City of Fredericksburg

Planning and Zoning Meeting Agenda
Wednesday, September 6, 2023 ~ 5:30 PM
Law Enforcement Center
1601 E. Main Street
Fredericksburg, Texas 78624

RE: Z-2319, Review Comments for Site Plan/Conditional Use Permit Review for a Limited Restaurant Located at 811 North Llano Street.

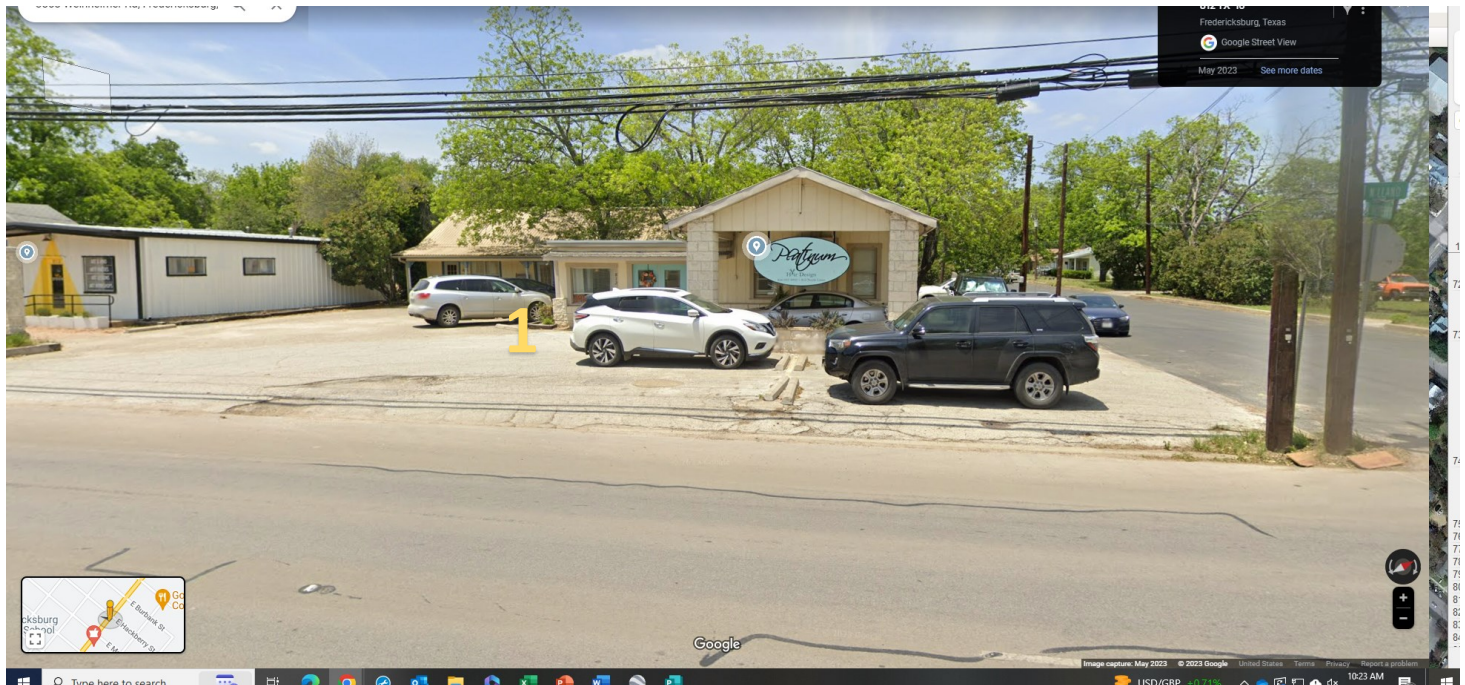
Curb cut to be removed as only one curb cut is allowed per lot of this size and new curb cut will be required for parking lot access.

1 SITE PLAN - PROPOSED
SCALE : 1/8" = 1'-0"

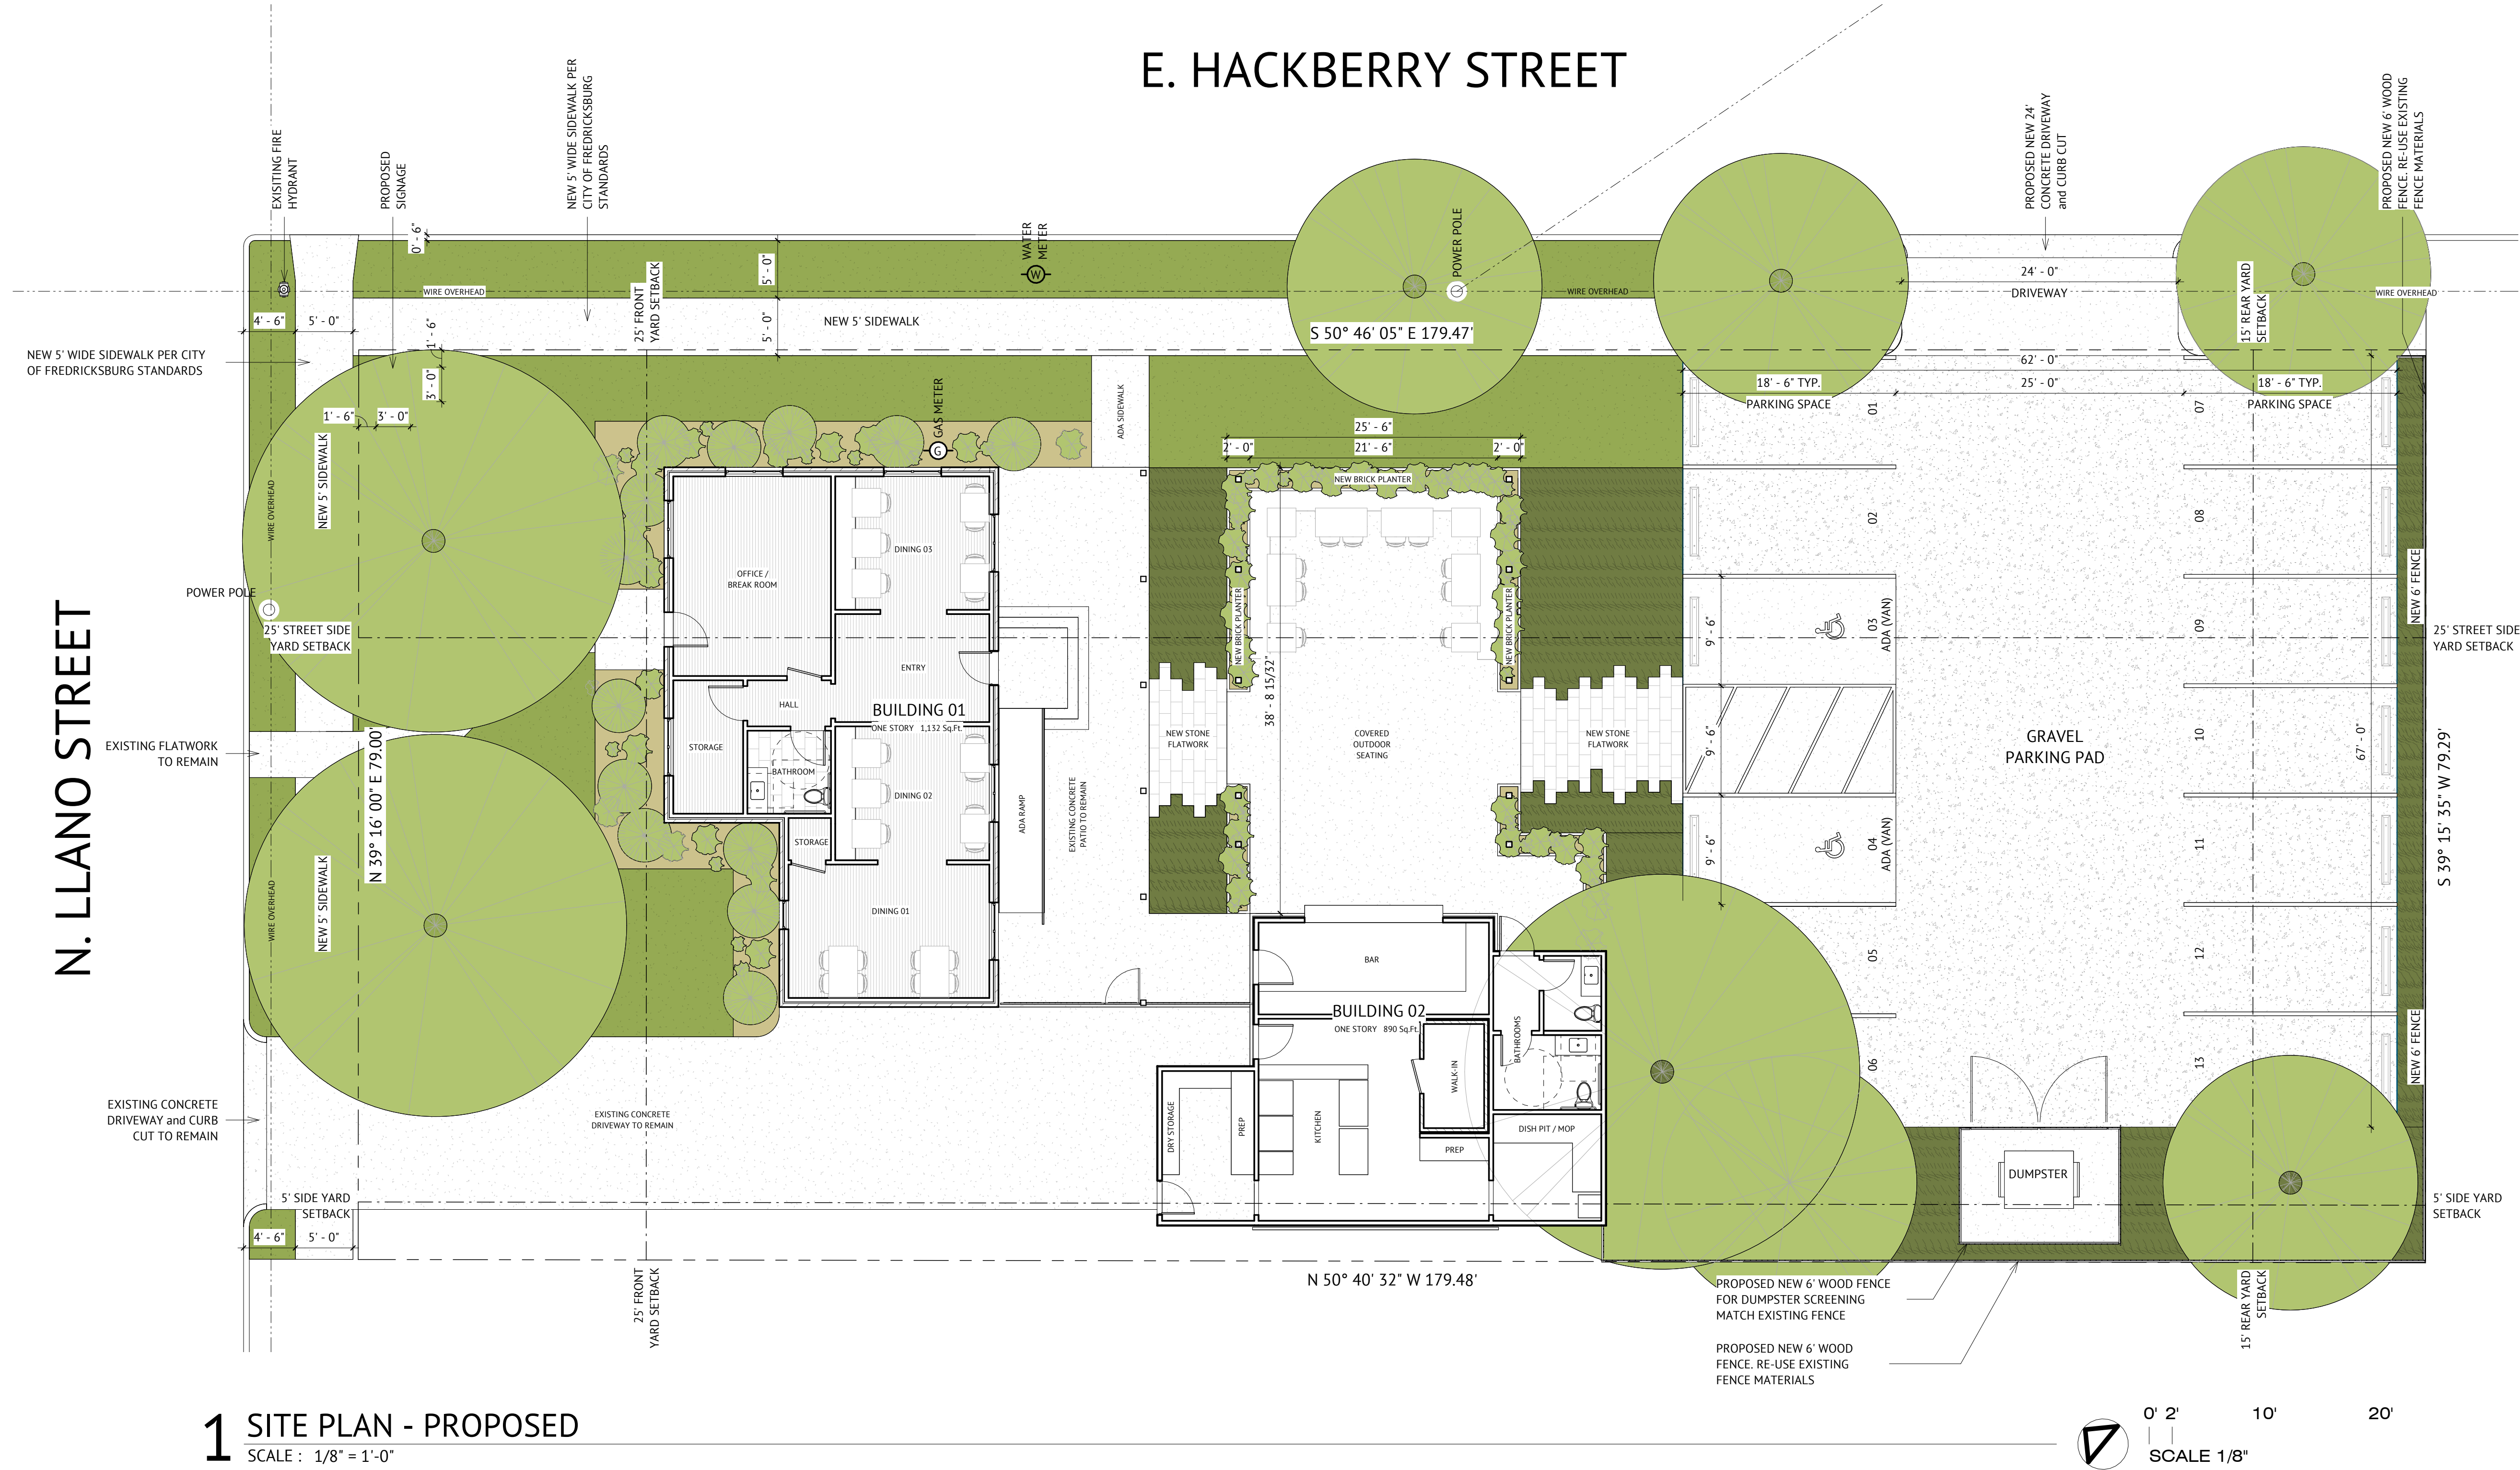
- The Site Plan requires Planning and Zoning Approval, tentatively scheduled for September 6, 2023.
- City standard sidewalk is a minimum of 5 feet wide. Please update note on public sidewalk shown. Cross slopes of existing concrete in the public sidewalk path must be ADA compliant.

- Provide ADA access from the public sidewalk to the building.
- Only one driveway is permitted along the E. Hackberry frontage. Please note the existing driveway has to be removed and replaced with City standard curbing.

- Dimension parking space width and ADA loading zone width.
- Describe how parking spaces are delineated on the gravel surface.
- Show site drainage flow arrows.
